HISTORIC AND DESIGN REVIEW COMMISSION

October 19, 2022

HDRC CASE NO: 2022-510
COMMON NAME: E Market at Hemisfair Park
LEGAL DESCRIPTION: NCB 13814 (HEMISFAIR - NORTHWEST QUADRANT), BLOCK 3 LOT 20
ZONING: D, H, RIO-3, Public Property
CITY COUNCIL DIST.: 1
DISTRICT: Hemisfair Historic District
APPLICANT: FitzGerald Associates Architects, PLLC
OWNER: PH Hemisfair LLC
TYPE OF WORK: Construction of a mixed-use tower, construction of a retail structure
APPLICATION RECEIVED: September 30, 2022
60-DAY REVIEW: Not applicable due to City Council Emergency Orders
CASE MANAGER: Edward Hall

1. Construct a 3-story retail structure to feature 2 stories above street level and 1 level at river level.
2. Construct a 29-story structure to feature residential and retail space. The proposed new construction will feature 360 residential units and 7 levels of structured parking.

2 SOUTH ELEVATION - BUILDING D1
1" = 40'-0"

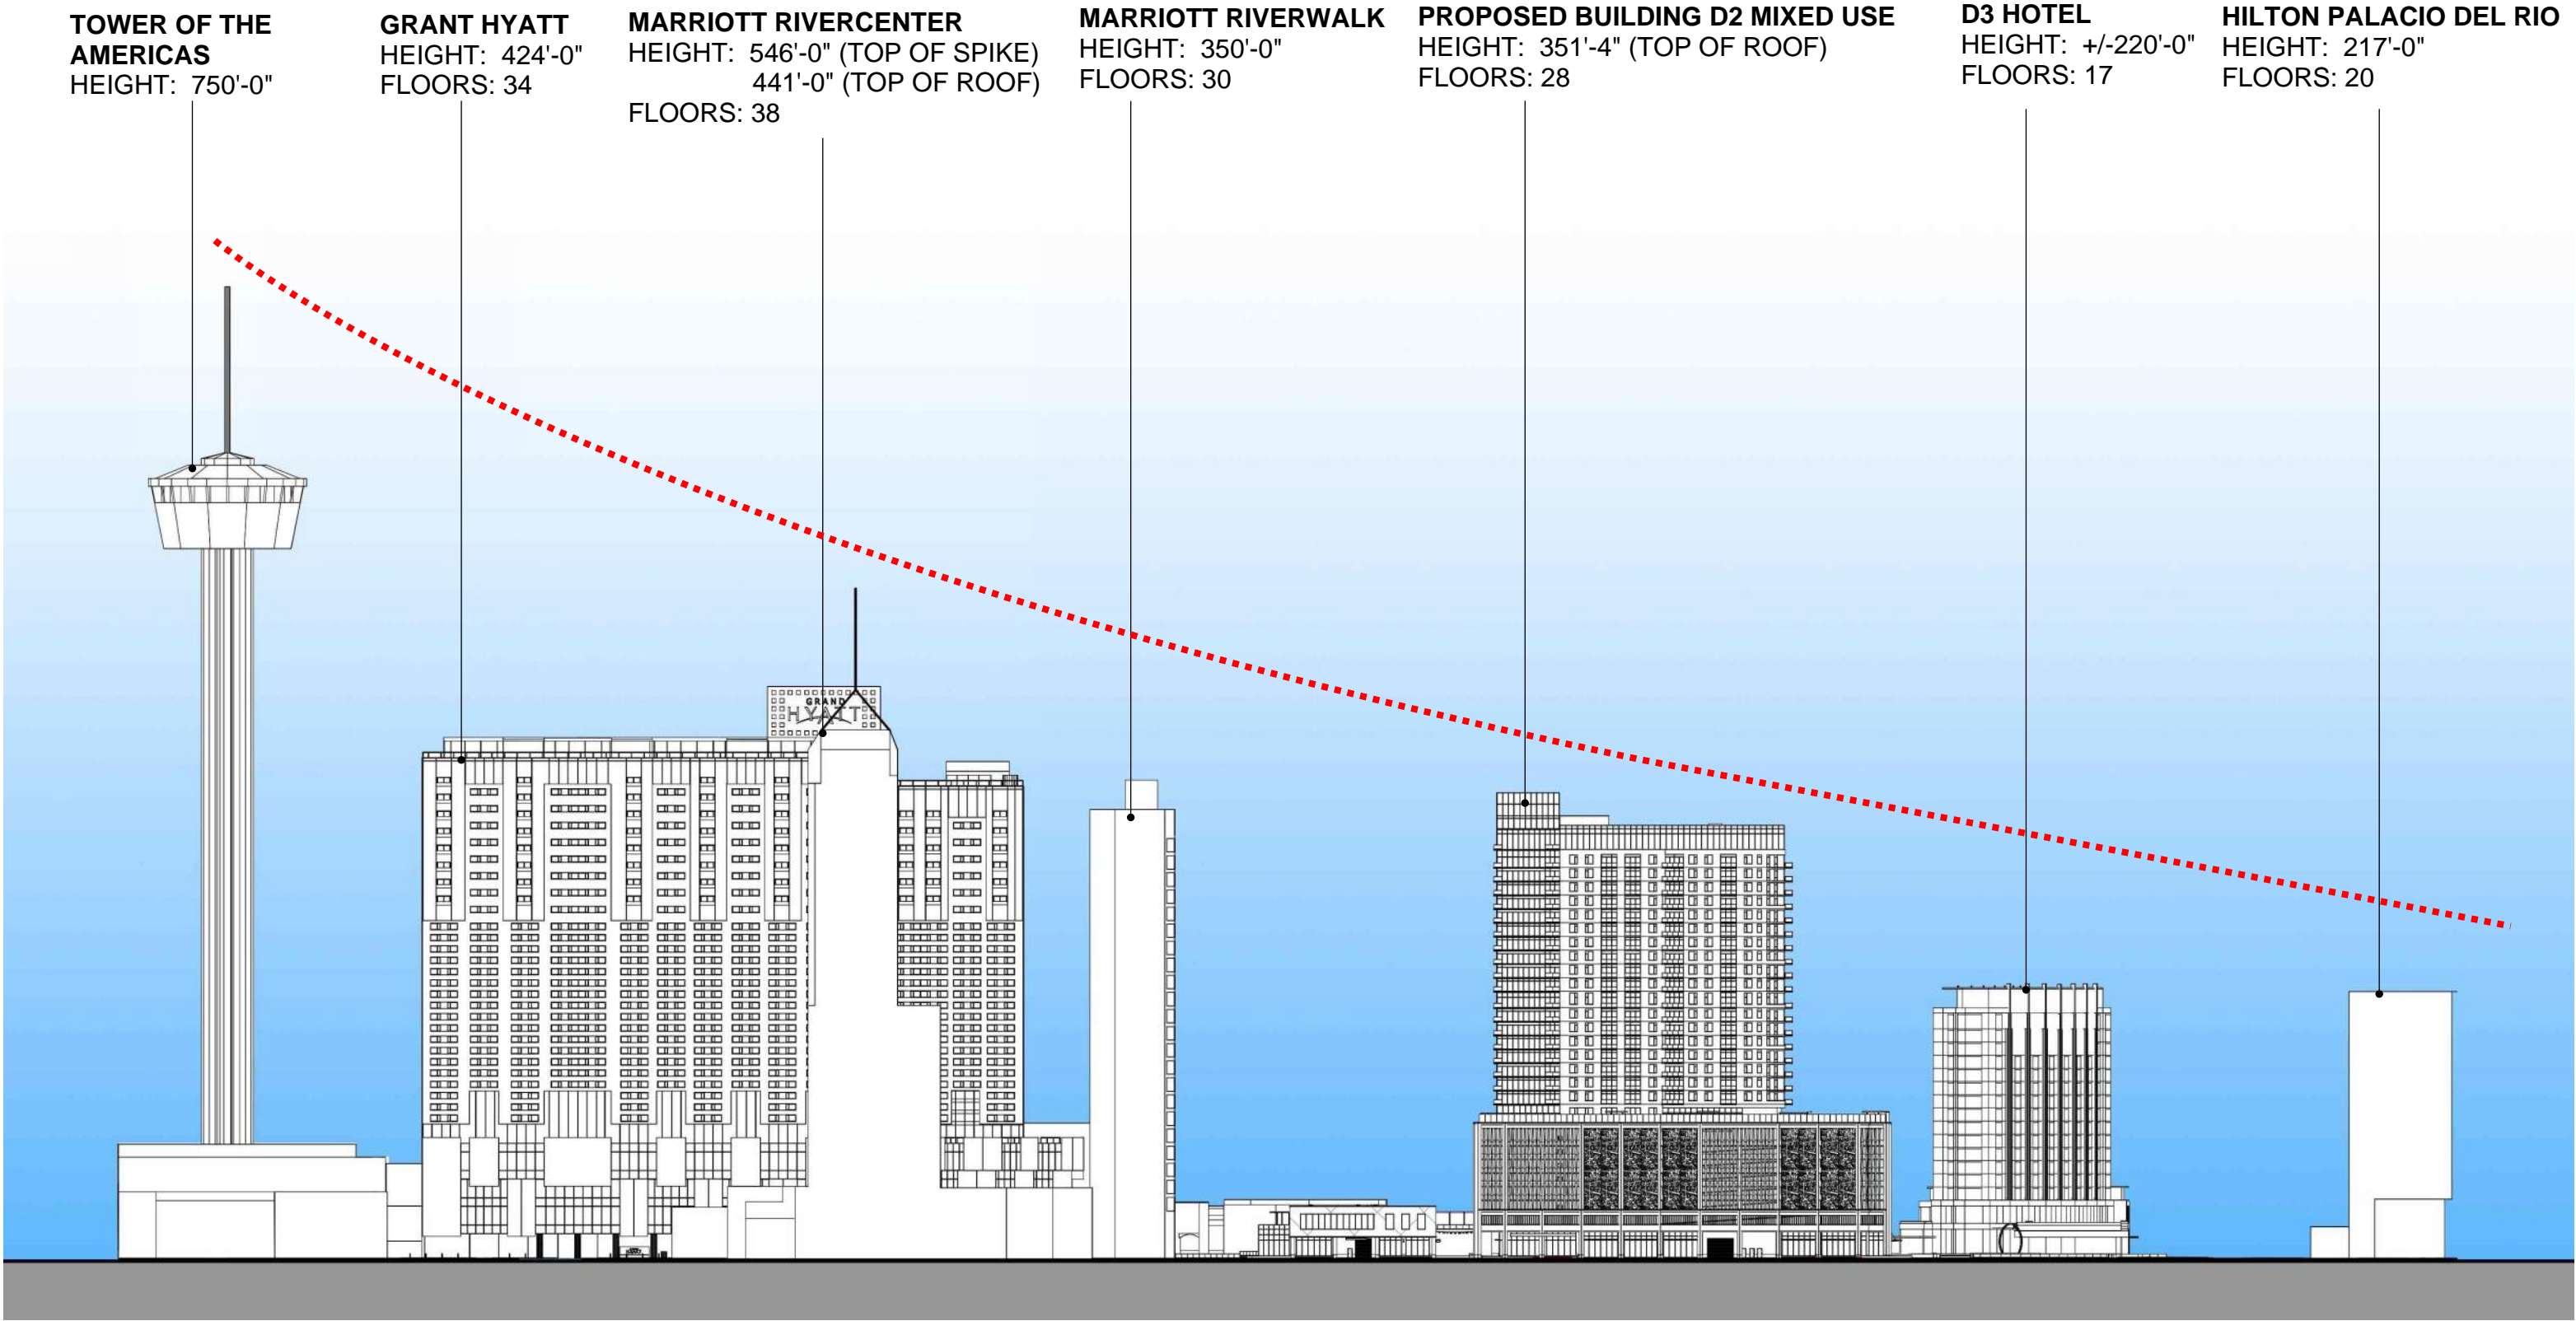
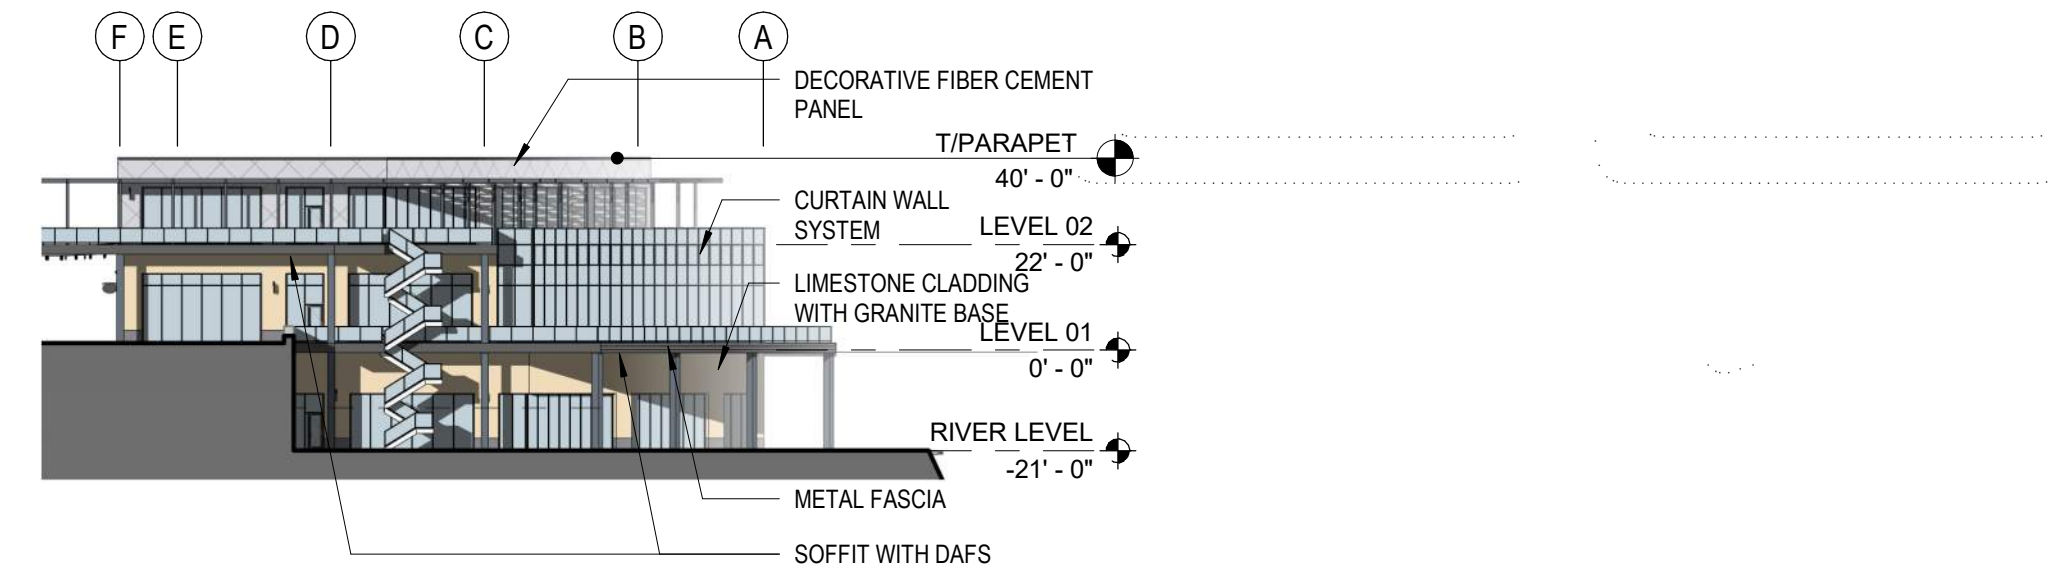
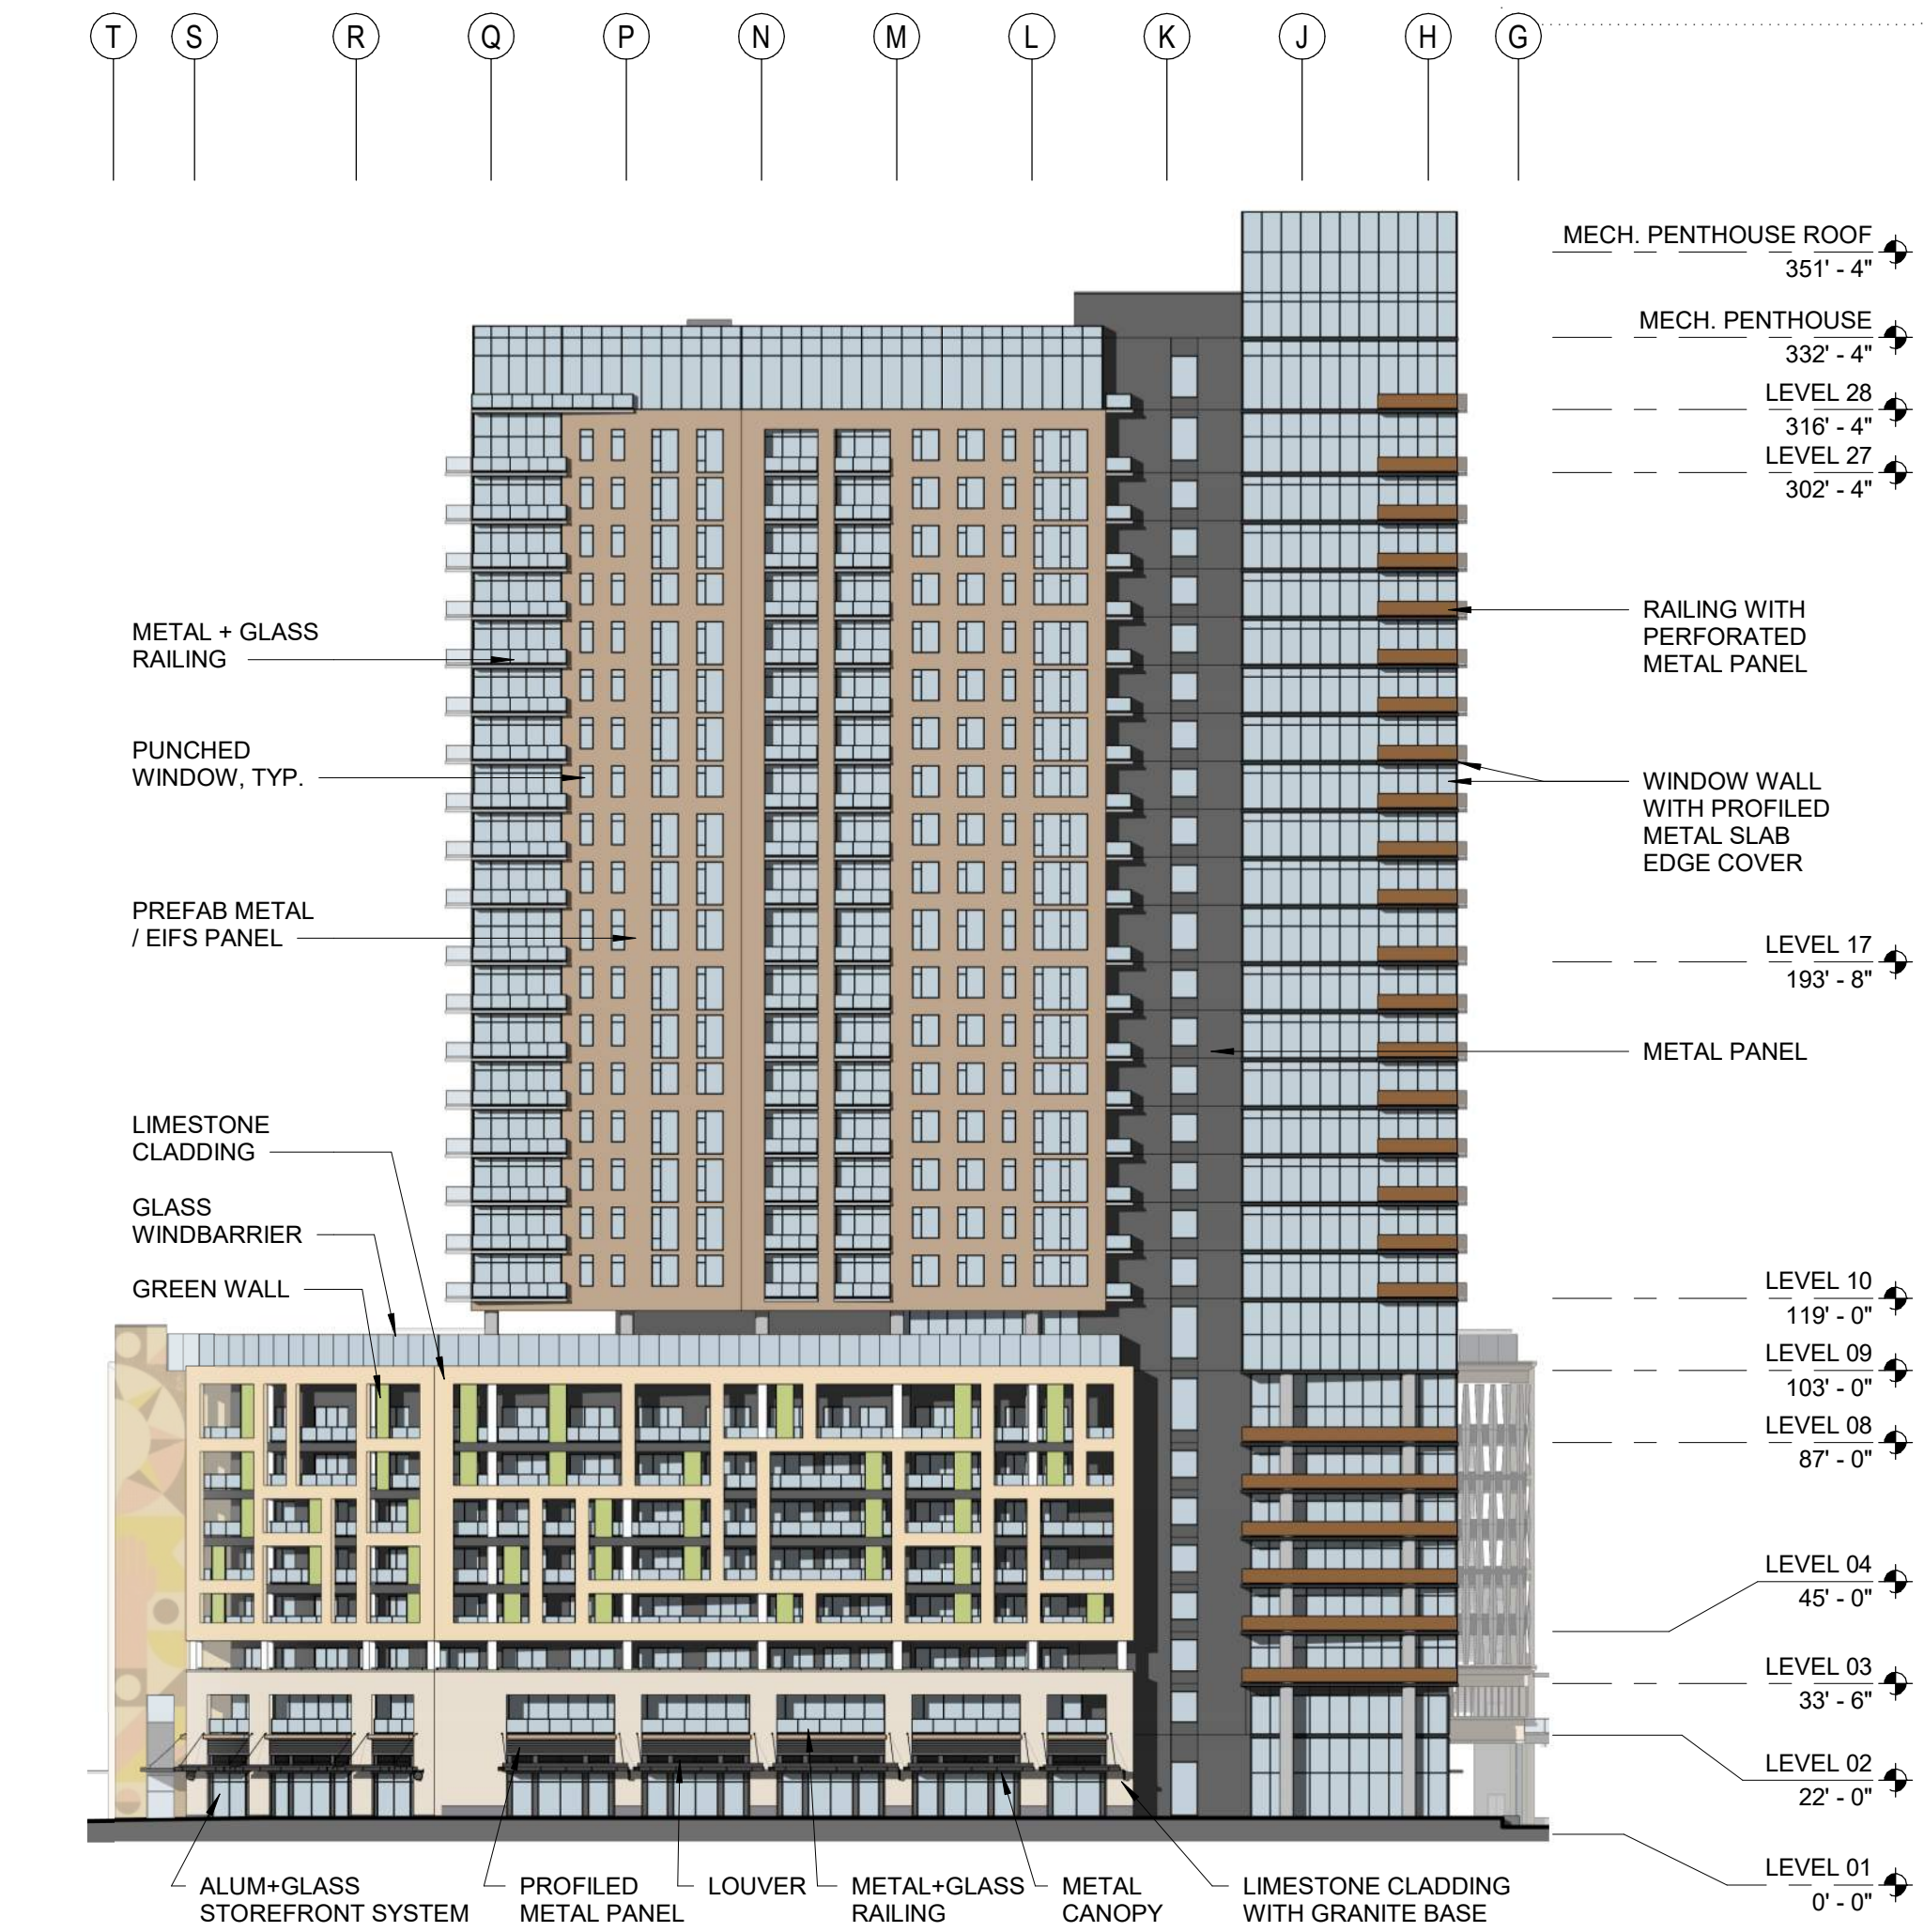
- 1b. BUILDING SCALE & MASSING – According to the UDC Section 35-674(b) a building shall appear to have a “human scale”. To comply with this, a building must (1) express façade components in ways that will help to establish building scale, (2) align horizontal building elements with others in the blockface to establish building scale, (3) express the distinction between upper and lower levels, (4) in this instance, divide the façade of the building into modules that express traditional dimension and (5) organize the mass of a building to provide solar access to the river. Where a building façade faces the street or river and exceeds the maximum façade length allowed per the UDC (thirty; 30 feet in RIO-3), the façade should be divided into modules that express traditional dimensions. Staff finds that the street level, river facing façade which is primarily composed of a glass curtain wall system be modified per the UDC Section 35-674.01(b)(4)(B). Staff finds that traditional structural bays should be articulated on the river façade and that those structural bays should be clad in traditional materials.

proposal provides a distinctive top through a change in predominate cladding material. Additional articulation or variation could be introduced to further meet this requirement.
